Re: Petition 1549– 1714 Line Rebuild Project

Response to CSC-01 Interrogatories dated January 11, 2023
Set 01 – Questions 1-42

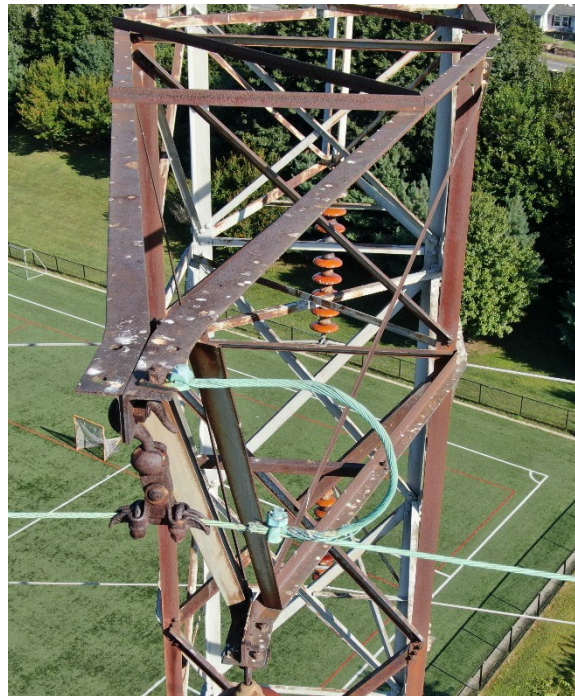
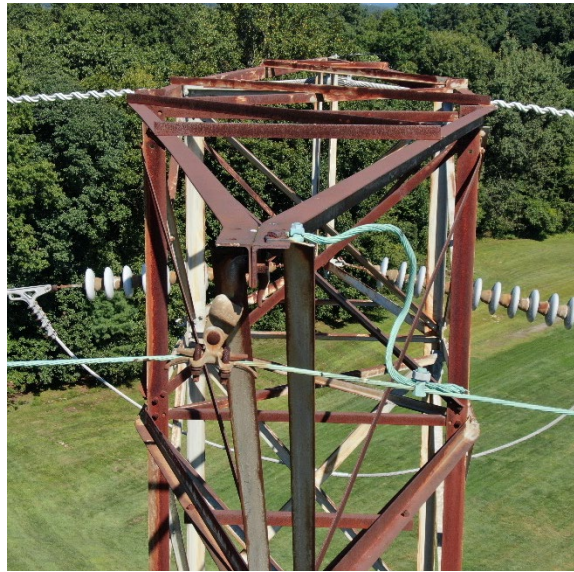
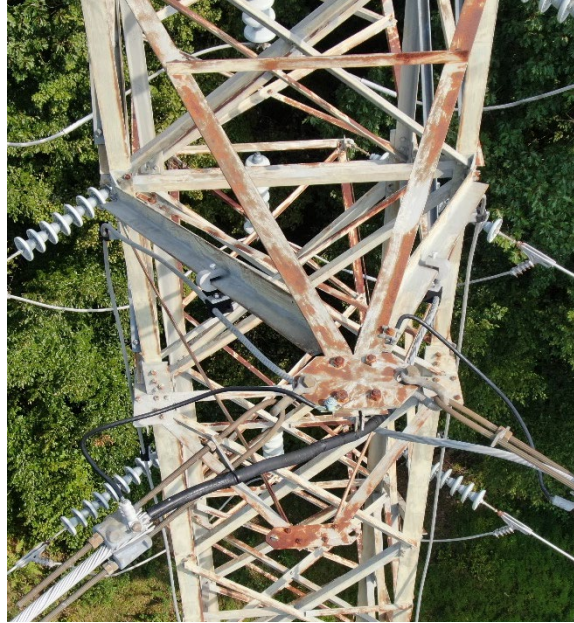
Provide sample photos of the asset conditions associated with the structures to be replaced.

Structure 859 - rust on structure and hardware

Structure. 860 - rust on structure and hardware

Structure. 861 - foundation damage

Structure. 863 - rust on structure and hardware

Structure. 869 - rust on structure and hardware

Structure. 872 - rust on structure and hardware

Structure. 887 - foundation damage

Structure. 888 - foundation damage

Structure. 889 - foundation damage

Structure. 890 - foundation damage

Structure. 891 - foundation damage

Structure. 892 - foundation damage

Structure. 894 - rust on structure and hardware

Structure. 897 - rust on structure and hardware and bent arm

Structure 899 - rust on structure and hardware

Structure 901 - rust on structure and hardware
